## Re: Submission on Plan Change 100 (PC100) to the Auckland Unitary Plan

## Submission on Proposed Plan Change 100 Auckland Unitary Plan (Operative in Part)

**SUBMISSION ON PRIVATE PLAN CHANGE 100 (RIVERHEAD) TO THE AUCKLAND UNITARY PLAN  
(OPERATIVE IN PART)**

**Figure 1: Existing site plan (site boundary shown by red line)**

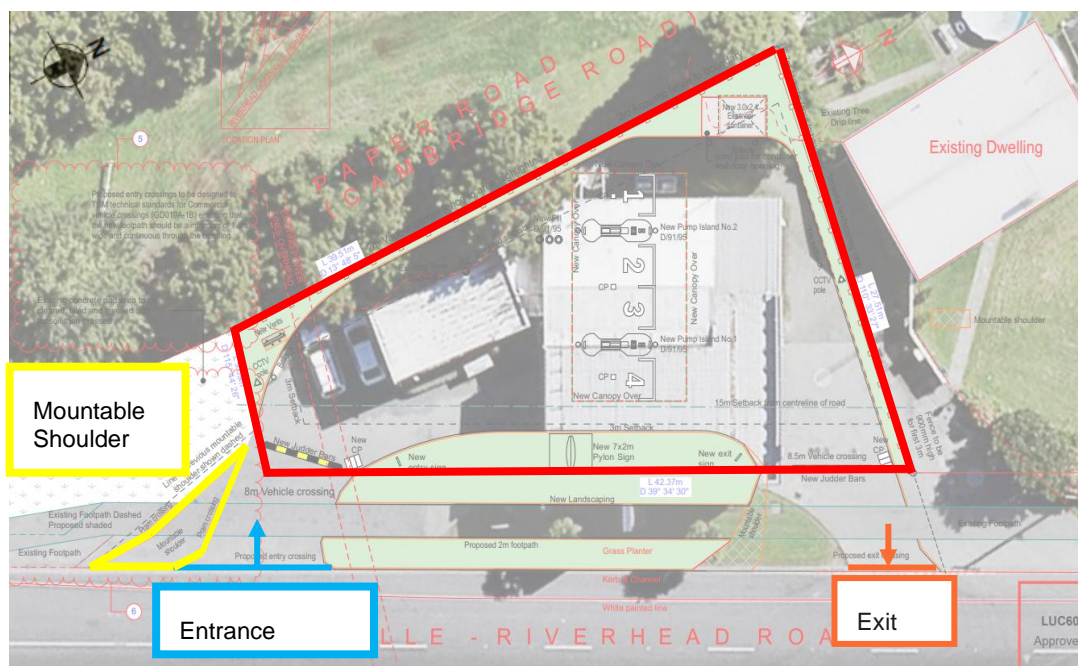
5. Caltex Riverhead was recently redeveloped as a service station having obtained resource consent in 2022 (LUC60392331 & DIS60398679). It is served by two existing crossings along the Coatesville-Riverhead Highway frontage, which tankers and customers use on a frequent basis. A mountable shoulder is positioned near the entrance crossing and extends over the property boundary, and this was approved by Auckland Transport as part of the resource consent to facilitate safe access for tankers entering the site. The site also has a building line restriction inside its front boundary. These site features are depicted in Figure 1 below. Z Energy seeks to ensure that these aspects of the site are not impacted by road changes proposed through PC100.

**Figure 2: PC100 Proposed Road Upgrades**

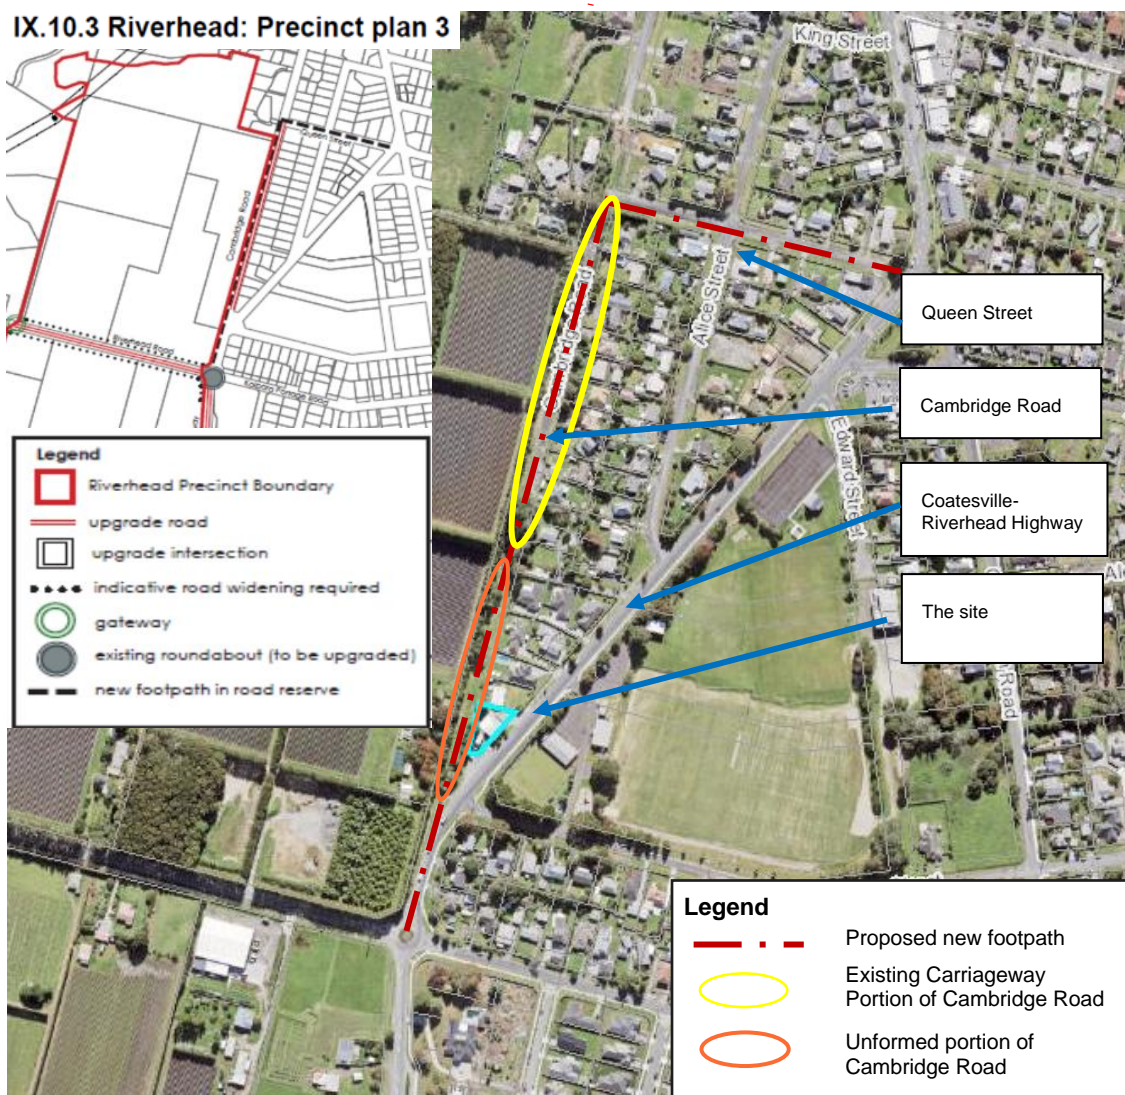
6. Standard IX.6.1(5) of the Proposed Riverhead Precinct Chapter requires that prior to occupation of a building on a site with vehicle access to and/or from Cambridge Road, (a) a new footpath shall be constructed on the western side of Cambridge Road between Queen Street and Riverhead Road, and (b) the existing carriageway of the formed portion of Cambridge Road shall be upgraded to an urban standard. Z Energy understands that the applicant's intention, consistent with these provisions, is to provide vehicle access for only the existing formed portion of Cambridge Road (to the north of Caltex Riverhead), with only a pedestrian footpath (no vehicle access) in the existing paper road portion of Cambridge Road next to Caltex Riverhead. Refer to Figure 2 below. Z Energy seeks confirmation regarding the road changes proposed through PC100, noting that Precinct Plan 3 indicates that there is potential for the entirety of Cambridge Road to be 'upgraded' (refer to Figure 2 below).

7. Z Energy supports the proposal for only a pedestrian footpath and no vehicle carriageway in the unformed portion of Cambridge Road next to Caltex Riverhead, if this is proposed as part of PC100. This arrangement ensures that vehicles can continue to safely enter the Caltex site, including via the mountable shoulder that sits outside its boundaries. If, on the other hand, a new vehicle carriageway was proposed at the Cambridge Road / Coatesville-Riverhead Highway intersection, this could

FIGURE 1: RIVERHEAD CORE RETAIL CATCHMENT

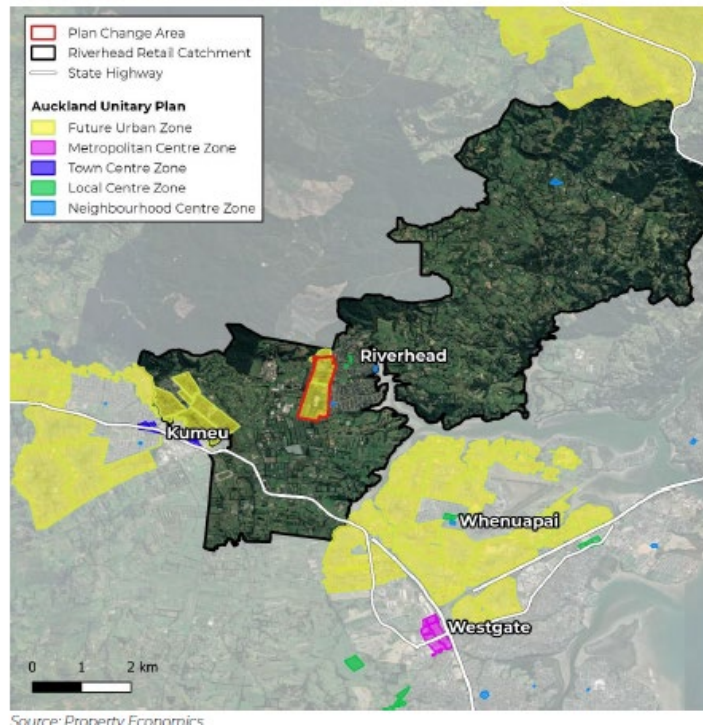
16. The basis for the proposed commercial zones is an economic report which predicts future demand (Appendix 7 – Centres Assessment). This report provides a cursory summary of the existing commercial activities and zoning. It also bases predicted demand on a ‘Riverhead Core Retail Catchment’. The report provides no basis for the extent of this catchment despite it being a formative assumption. Astonishingly, the catchment extends and wraps around Kumeu and goes all the way to the Dairy Flat Highway.

17. Defining this as a catchment for Riverhead as a retail destination is ridiculous at both extents of the area shown. People in the Kumeu area have no incentive to travel to Riverhead for shopping. Kumeu is well served with a supermarket and a huge range of retail and commercial services. Council’s own consultation documents for Kumeu show the extensive land at Kumeu dedicated for these activities.

PPC-100 GREEN CORRIDOR.

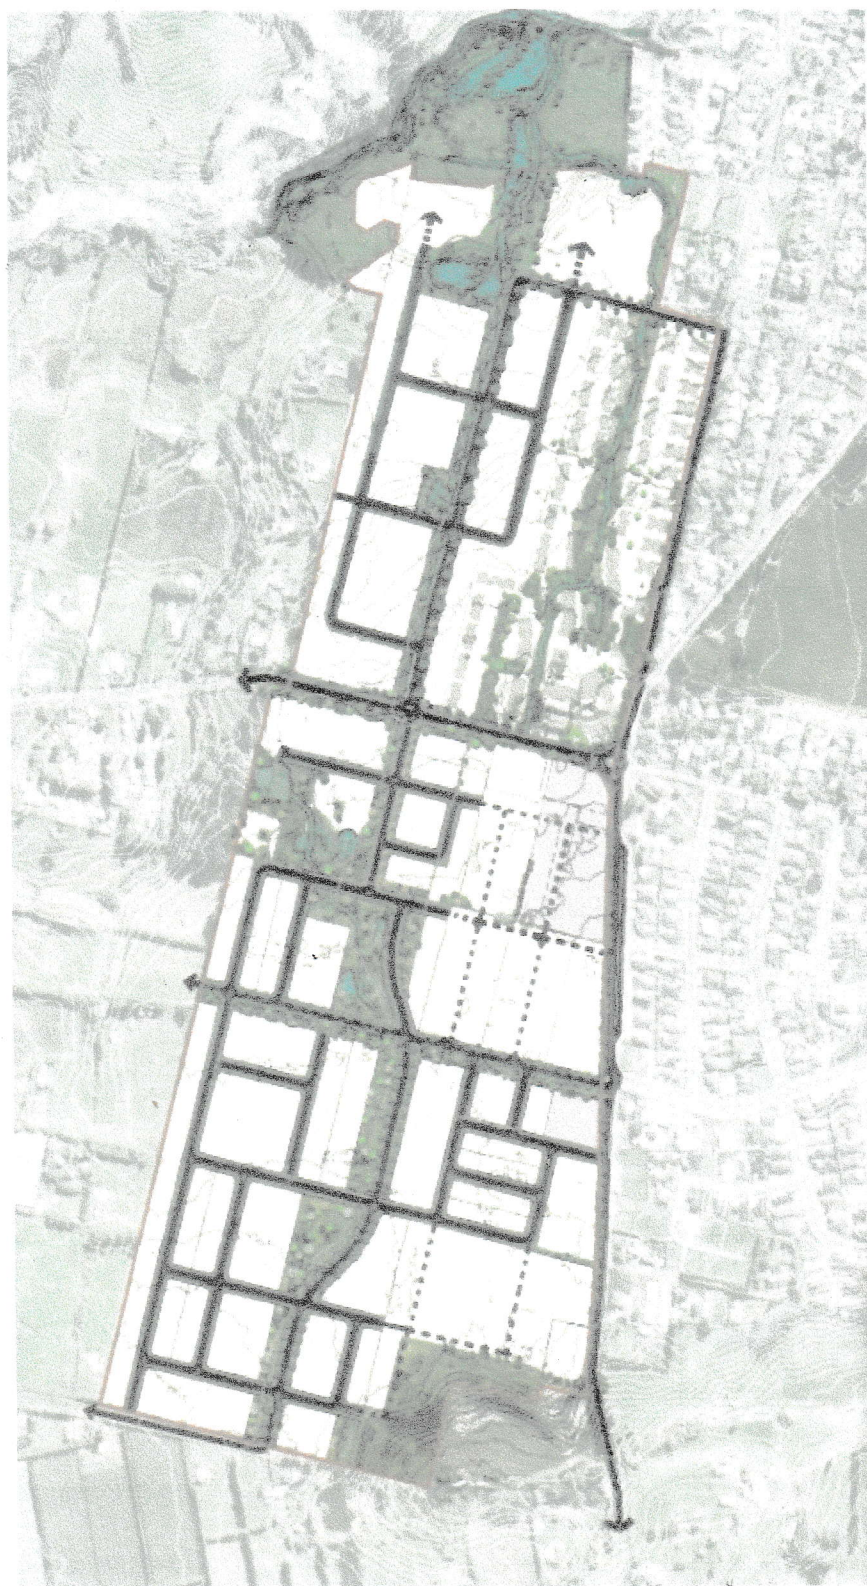
The reason for my or our views are:  
Having read the PPC 100 Riverhead Community Association Submission Final response document I support every point made and the suggested solutions. The other things that thoroughly irks me is the THAB's that brings with it the associated intensification - THIS IS NOT RIVERHEAD. I don't recall any information that clarifies whether the Apartments and Terraced units will have off-street garaging for all the occupiers, if not you can imagine how clogged the streets will be, starting to look like Avondale!! The Parks areas don't look like Parks but more like "Small Greens" the size of a postage stamp, no quality offered there. The green corridor running through offers nothing other

than the appearance of a covered stormwater drain, to call it multi-purpose is a gross exaggeration, surely the design team can be more imaginative. The Plan Change and the proposed housing needs to be clarified more about how high the Apartments will be, is it 3 stories or 6 stories??? And again what about Apartment and THAB Occupiers garaging of their vehicles. The Neighbourhood Centre location looks weird - out on its own.
